20 December 2017

**NSW Planning Assessment Commission Determination Report
Wambo Coal Mine (DA 305-7-2003 MOD 17)**

Figure 2: Plan and bore logs of recent bores drilled adjacent to North Wambo Creek (Source: Wambo Coal Pty Ltd)

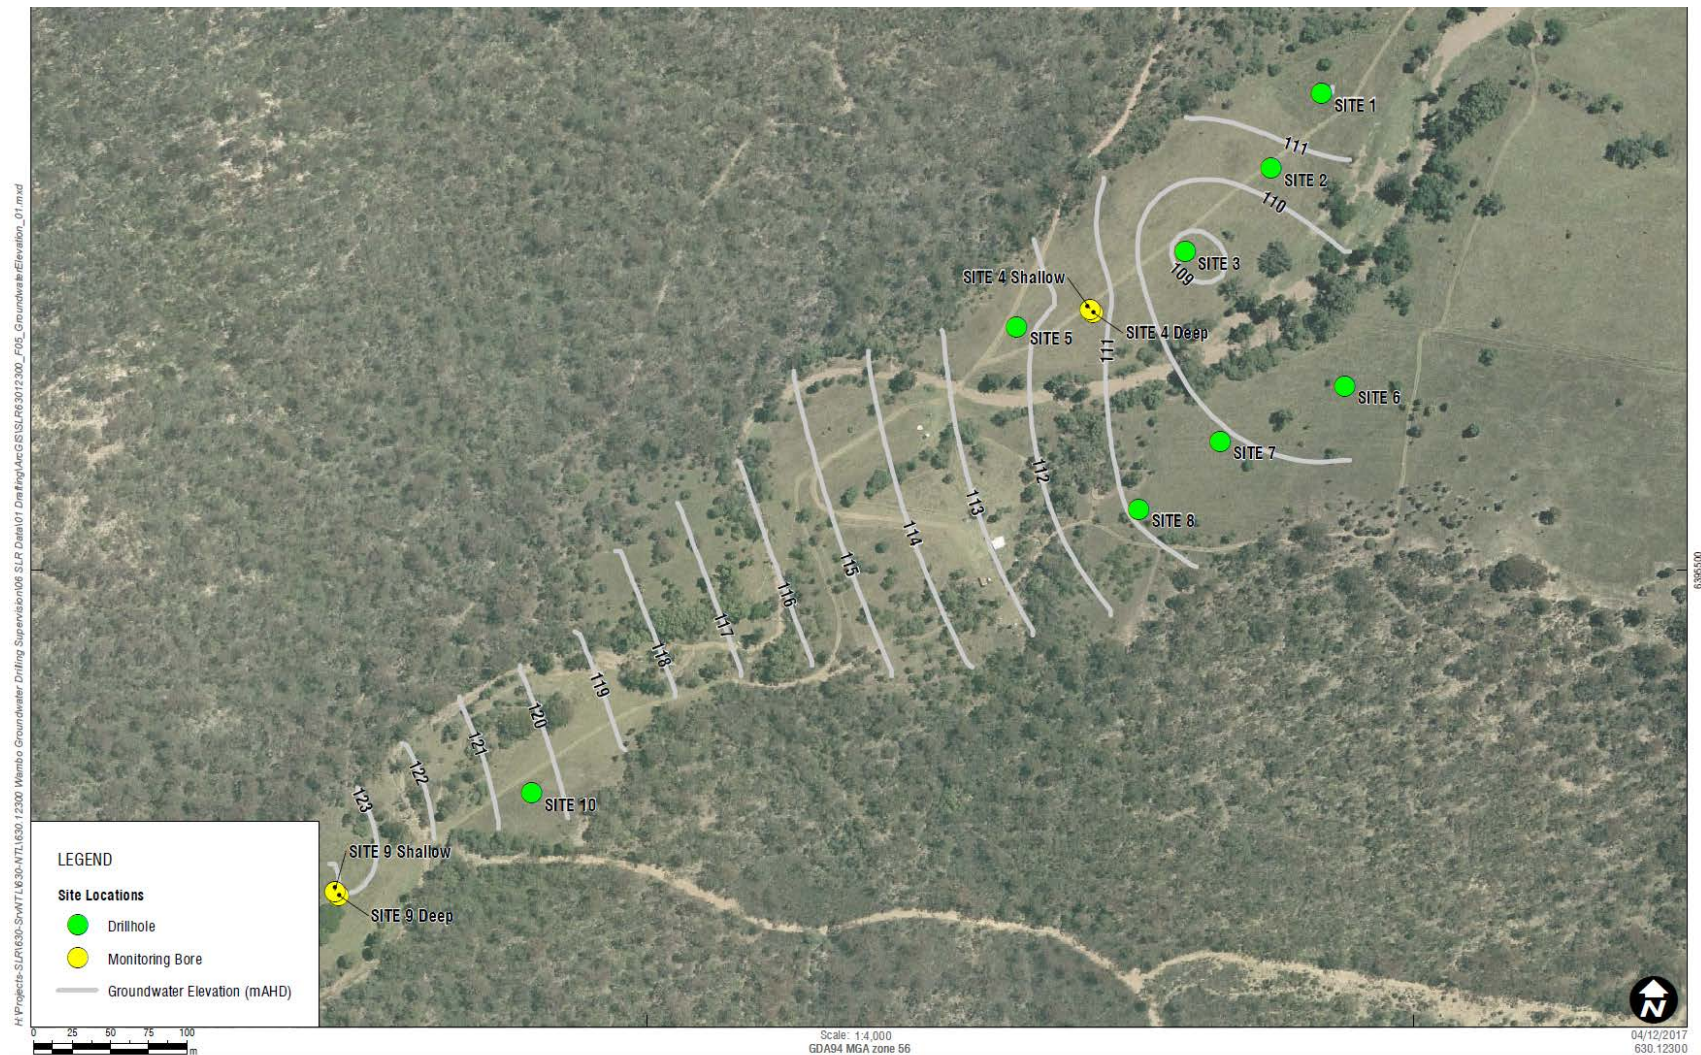
During the site inspection, the proponent identified recently commissioned investigative drilling and the installation of piezometers (bores) in the vicinity of North Wambo Creek. On 13 December 2017, the proponent submitted information to the Commission confirming that the program comprised 12 bores at 10 sites, four of which (at two sites) were constructed as permanent monitoring bores. The drilling was completed on 21 November 2017. The aim of the program was to measure groundwater levels in the unconsolidated sediments. The bores measured the standing groundwater level and logged the nature of material encountered. The constructed monitoring bores will allow the long-term monitoring of groundwater levels in the vicinity of North Wambo Creek (see **Figure 2**).

The proponent confirms it consulted CLWD on the monitoring locations and is working to address CLWD's monitoring requirements, including the installation of additional piezometers in 2018. CLWD supported the proposed bore locations and requested an additional 9 to 12 bores. The proponent proposes to undertake the additional drilling in early 2018.

The Commission finds that the presence and subsequent significance of GDEs is inconclusive, given the limited availability of monitoring data. Based on the information submitted, the Commission finds that the approach of additional monitoring to determine groundwater levels is appropriate and amendments to Condition 36B would require a minimum of two-years of data being collected. This would allow for the satisfactory assessment of groundwater dependability prior to any Extraction Plan being submitted for longwalls 23-25. The amendment to Table 14A, Condition 22 provides clarification as to the relevant performance measure should GDEs be identified.
